Transportation Engineering Design Standards (TEDS) Exception Request

Project: T-Four Simple Subdivision

Transportation Engineering Design Standards (TEDS) Exception Recommendation Form

Transportation Engineering Design Standards (TEDS) Exception Approval / Denial Form

G Road Street Section from TEDS Chapter 6

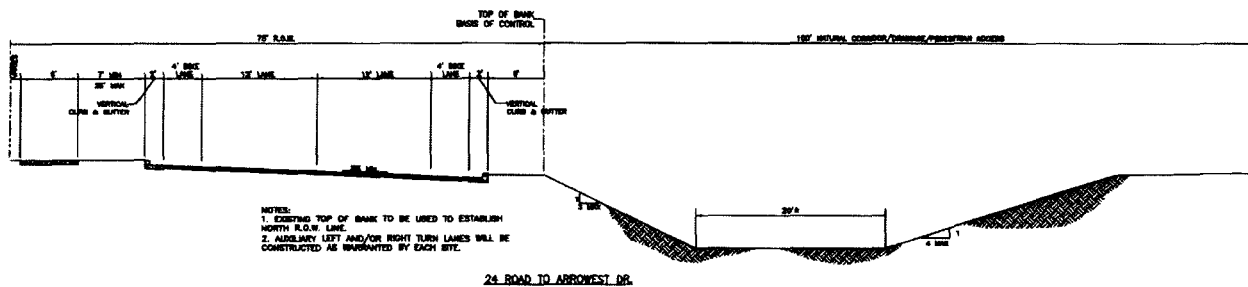
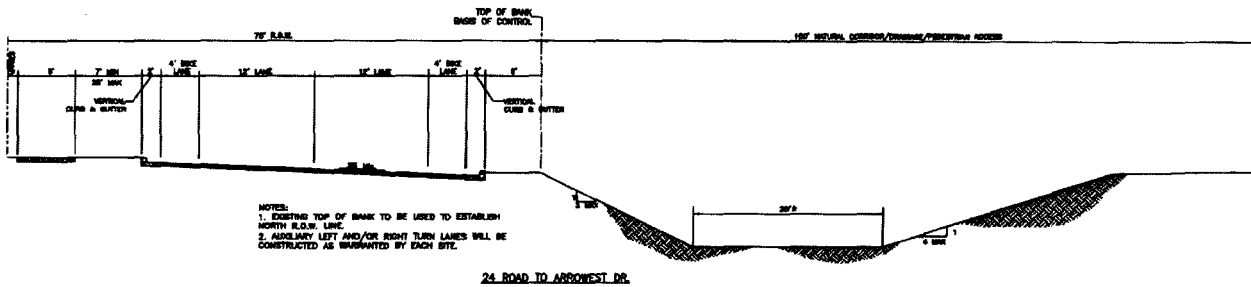
Request #1 - TEDS 6.1.1 – Reduce width of “100’ natural corridor/drainage/pedestrian access” as shown below to 51’ in the area adjacent to the property described in this application.

Figure 4

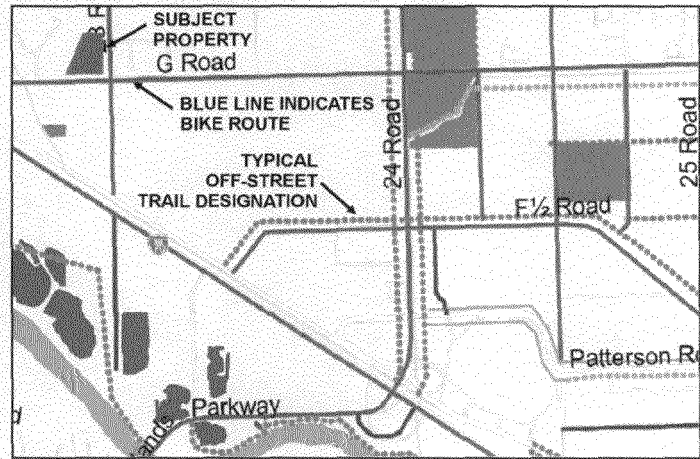
3. The G Road Section identifies the 100' corridor to include pedestrian access. However, the current Urban Trails Master Plan does not include a pedestrian path at this location. For this reason, a pedestrian access is not required for this section of G Road. A copy of the area of interest from the Urban Trails Master Plan is shown in Figure 4.

The proposed section follows:

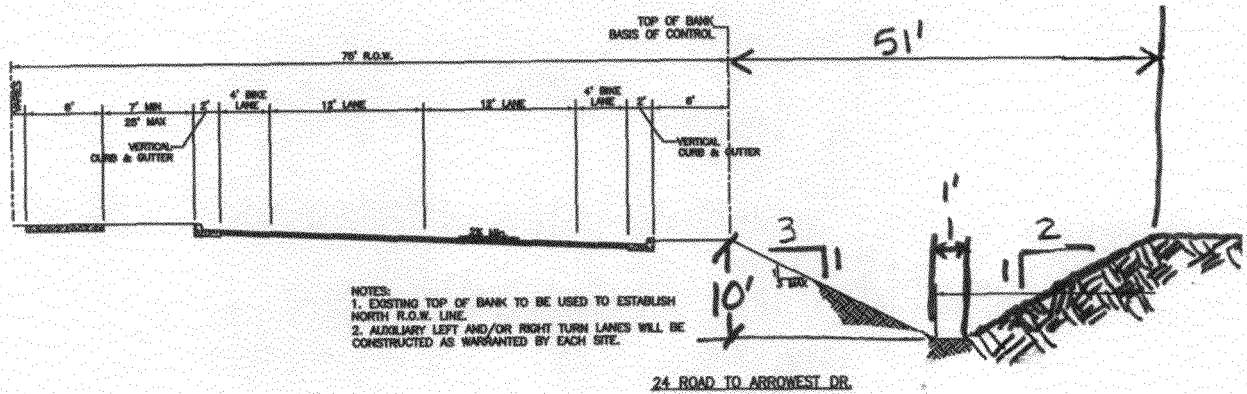
The G Road Section referenced in Section 6.1.1 indicates a 100' corridor on the north side of G Road from 24 Road to Arrowwest Drive. The petitioner requests the corridor adjacent to the property described above be reduced per the following Criteria.

1. The TEDS cross section indicates the easement is to begin at the top of south bank of the drainage. The designation is labeled and identified by linetype.

4. The existing slope for the drainage channel on the south varies from 1.5:1 to 2:1. The G Road Section indicates a 3:1 slope is required. The maximum elevation change is at the west end of the property at a elevation change of 10 feet. The required width to meet the 3:1 slope is 30 feet. No exception is requested.

5. The existing width of the channel bottom is roughly 1 foot. The width of the channel is assumed to be sufficient as indicated in the 1998 Grand Valley Stormwater Management Master Plan where the drain is identified as having sufficient capacity to act as a linear detention. Therefore this request does not include the 20' wide channel width as shown in the G Road Section and the historical 1' width is requested.

6. The existing slope for the drainage channel on the north varies from 1.5:1 to 2:1. The G Road Section indicates a 4:1 slope. We assume the decrease in slope on this side of the channel is to allow for the pedestrian access described above. This request includes changing to slope to 2:1 given that the north side of the channel will not include public access.

Considering the shortage of vacant property zoned for industrial use and that the 100' corridor requirement would reduce the usable industrial area by 1.3 acres. Acceptance of this exception request will lower that unusable area to 0.13 acres.

MODIFIED G ROAD
CROSS SECTION

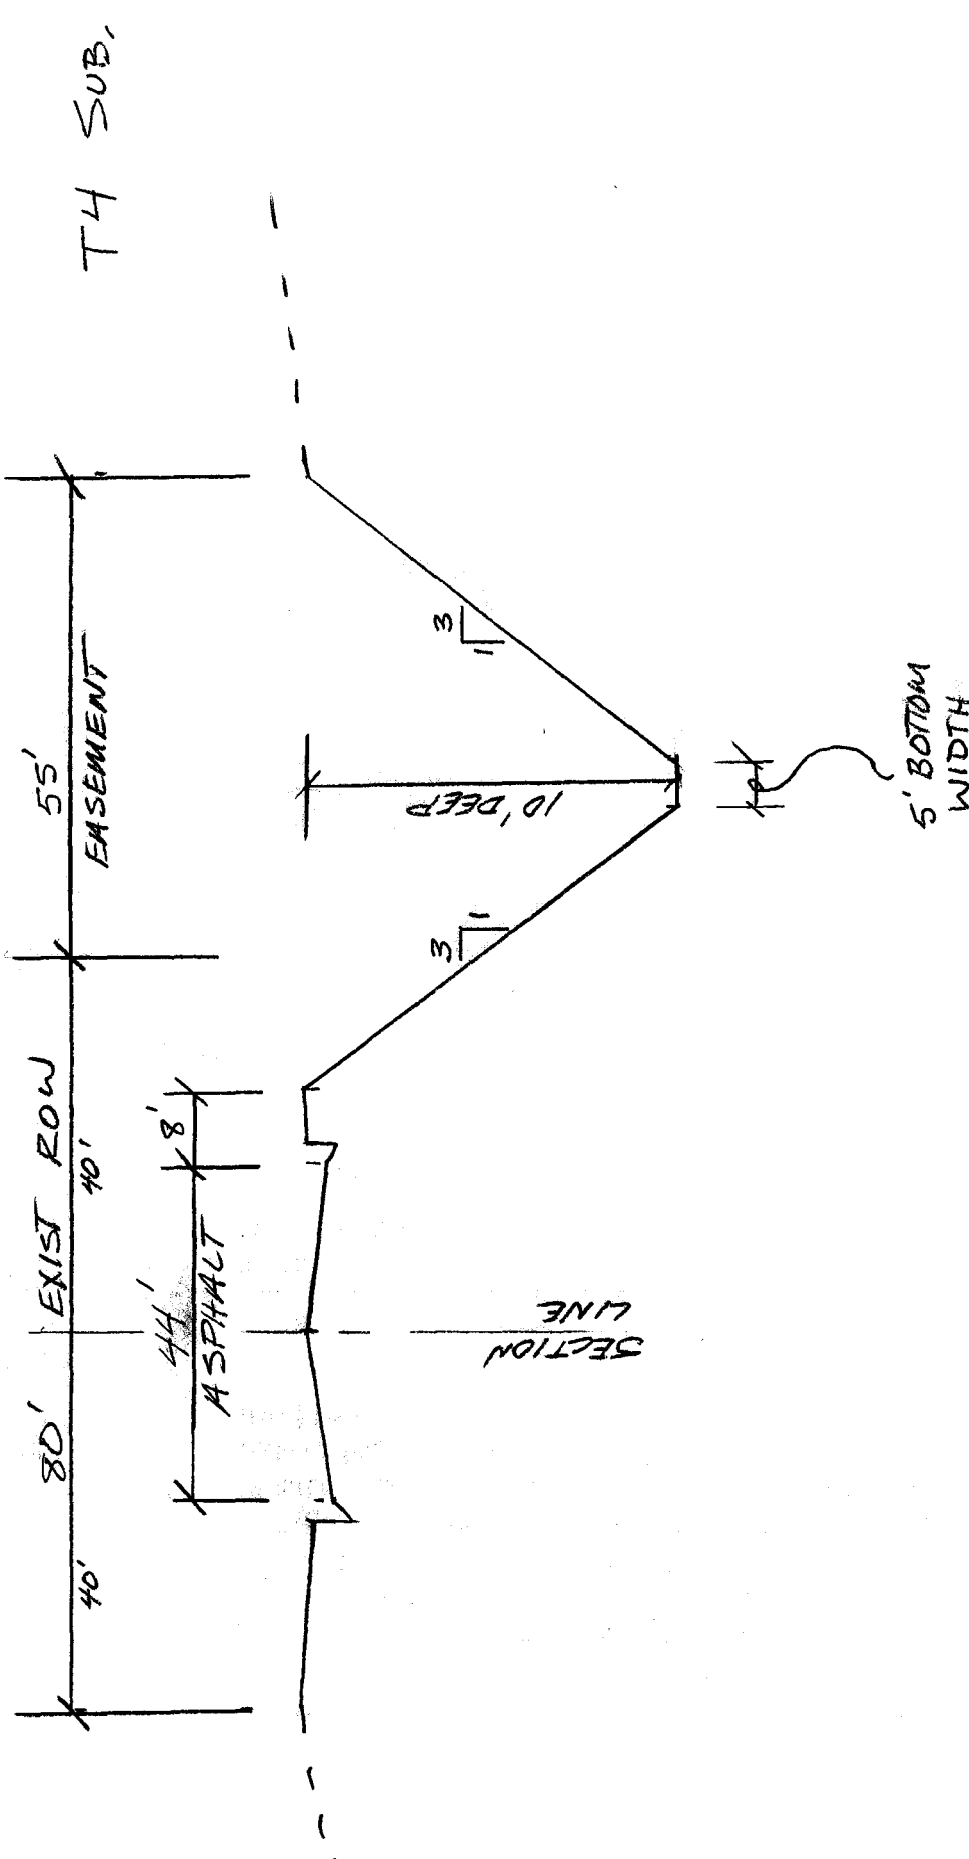
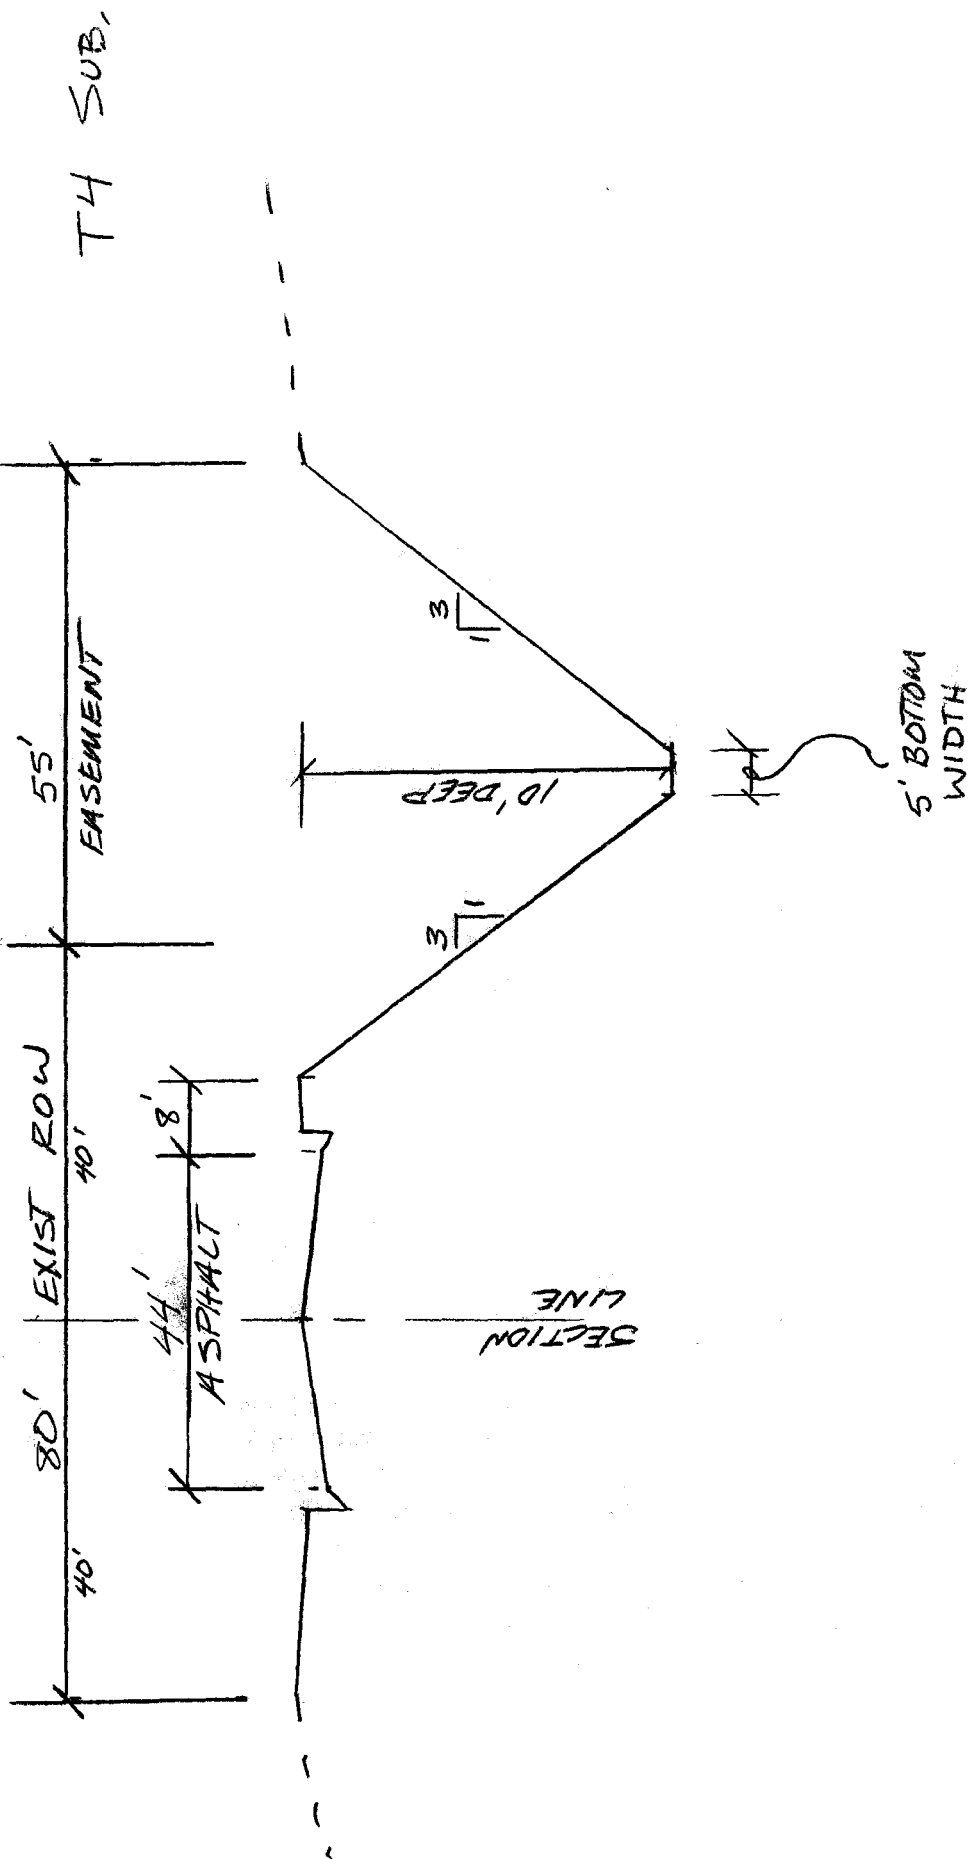
The G Road section in chapter 6 of TEDS uses the top of bank as control. This was drawn for the area where G Road parallels Leach Creek and the top of bank should be used as control. The purpose was to keep Leach Creek and open channel obtain right of way on the north side of G Road to construct an adequate street section north of Leach Creek. Unfortunately, the G Road section west of 23 Road also uses top of bank as control. This is erroneous for this section of G Road. 80' of Right of way currently exists for this section, 40' north and south of the section line. The Cannery Drain is mostly in the existing right of way and they are proposing to use top of bank as control. This will limit our ability to widen G Road in the future. Again the purpose is to keep the Cannery Drain an open channel. This avoids the expense of piping it plus provide detention volume identified in the GV-SWMP. If it was piped, the lost detention volume would need to be created off channel. The logical place would be on this parcel.

The G road section also anticipated a pedestrian trail along the Cannery Drain but the Urban Trails master plan doesn't show one. The G Road section does have on street bike lanes. There is no sidewalk since this is an industrial area.

My recommendation is to center a three-lane section on the section line and construct a modified section as drawn on the attached sheet. This will reduce the 100' easement past top of bank to only 55' past right of way. The recommended section uses 3:1 side slopes for the channel with a 5' bottom width. They recommended 3:1 on the street side, a 1' bottom width, and 2:1 on the north side of the drain. I don't want to use a 2:1 because they are more susceptible to erosion and more difficult to maintain.

MODIFIED G ROAD
CROSS SECTION

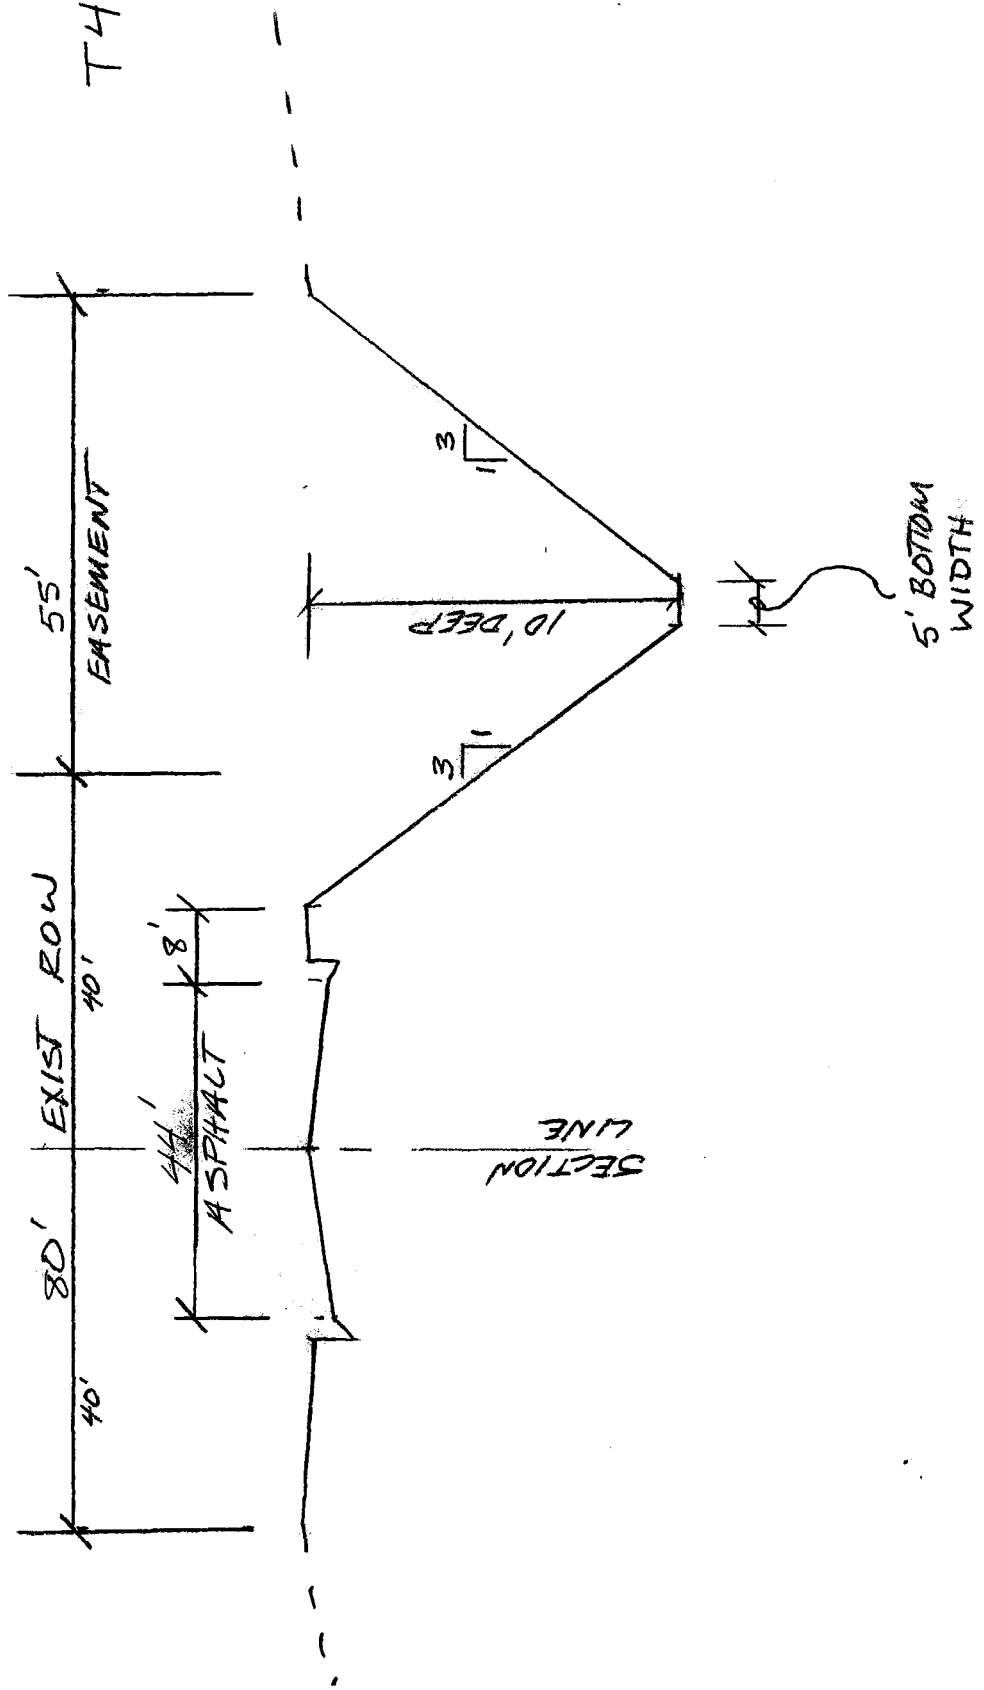
Approved with the following modification(s): See attached cross section.
